# Parc Solar Caenewydd, Swansea

## Archaeological Field Surveys Background Statement

## Parc Solar Caenewydd – Archaeological field surveys background statement

Parc Solar  
P00159

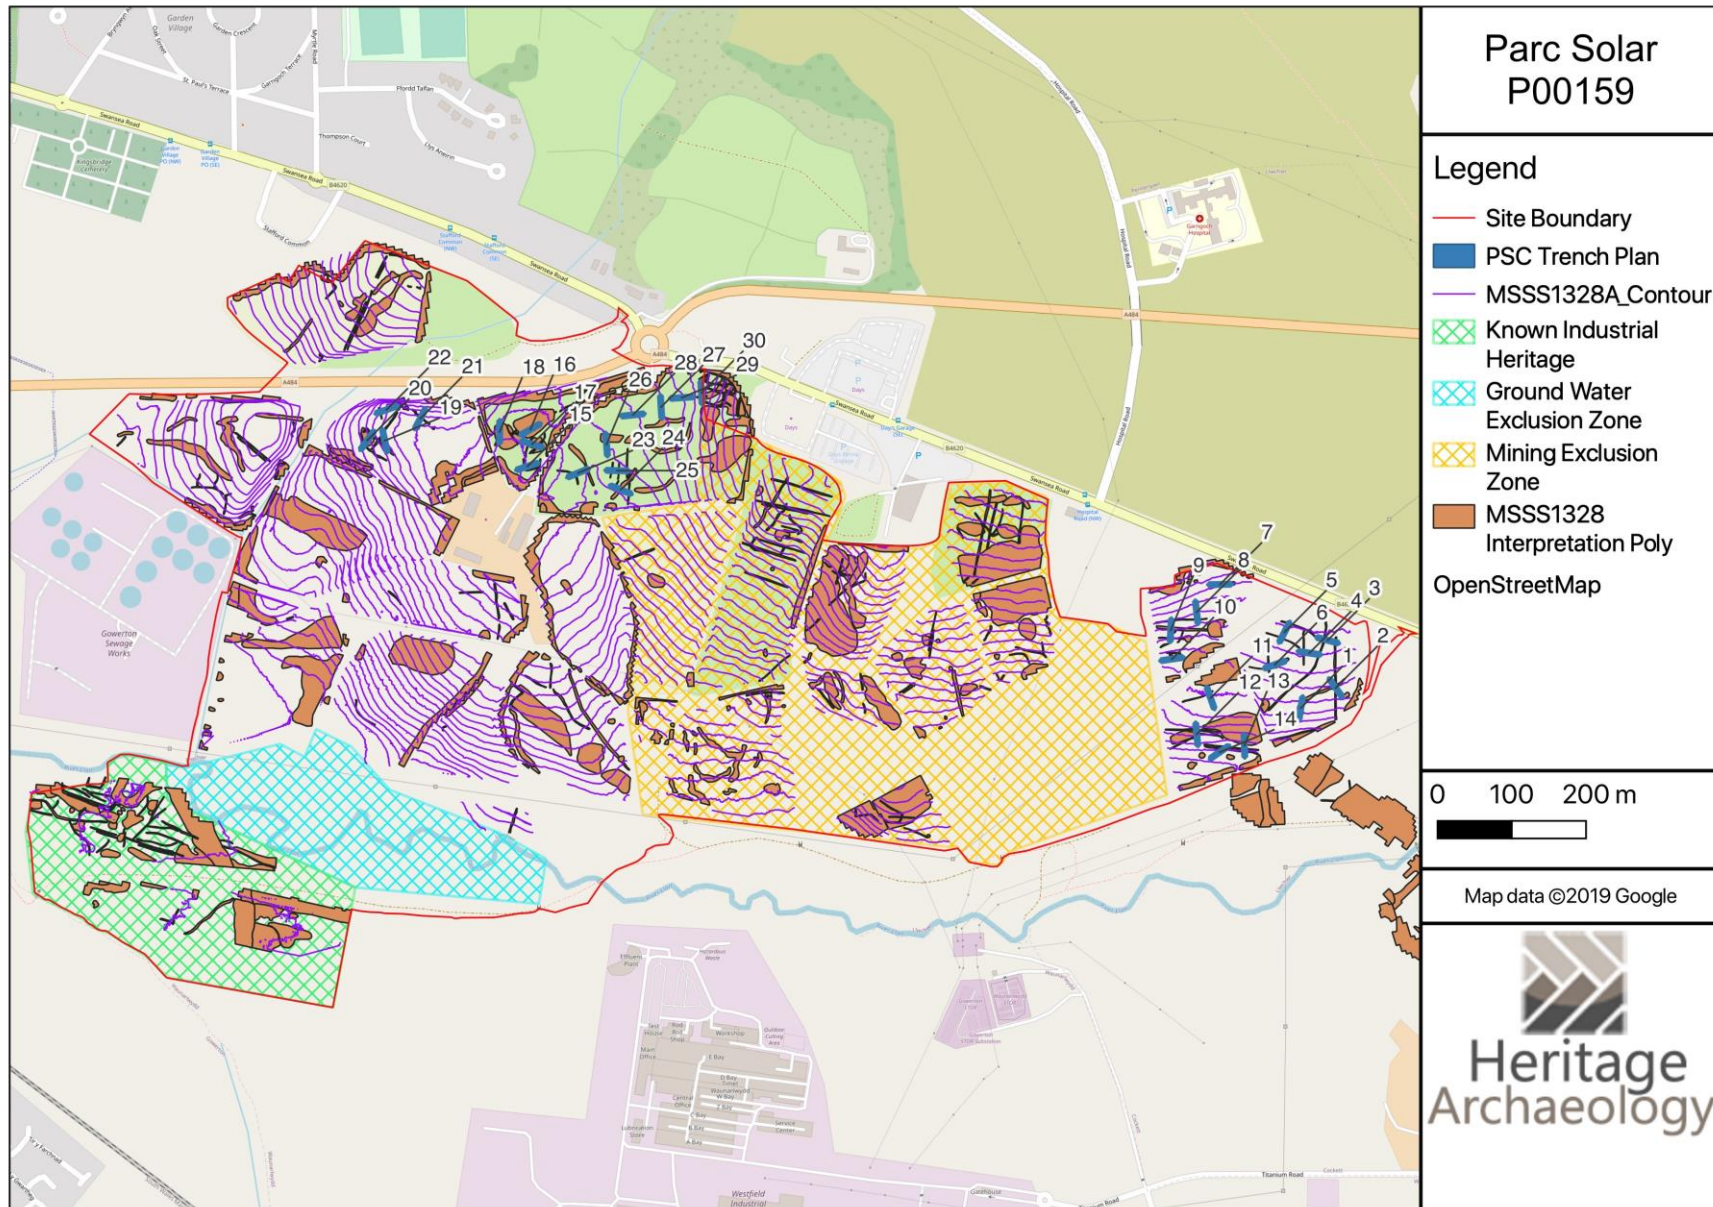
Date	Message	Response
	<p>Please do not hesitate to get back to me with any comments or queries on the above or attached. Kind regards Helena</p>	<p><u>suggested that this may be a good area to use to pick up some of the anomalies that he would still like to see tested</u></p> <p>HK asked RD about timescales; RD was happy with the WSI in general and would be able to approve it once the above amendments are made. RD asked whether trenching would be proposed in the areas to be surveyed next week – HK said that the results would be looked at and a second phase of trenching proposed as necessary</p>
15/11/2022	<p>Email from HK to RD</p> <p>Hi Rob Please find the updated WSI attached, combining the information sent through yesterday. We are still hoping for a start this week, if the attached is acceptable. Many thanks Helena</p>	<p>Email from RD to HK – 15/11/2022</p> <p>Dear Helena, Thanks for the amendments, which all make sense. As discussed, I think it important to note that this is very likely only the first phase of evaluation works. If you could keep me updated with regards to progress that would be great, and we can arrange a site visit when appropriate. Regards, Rob</p>
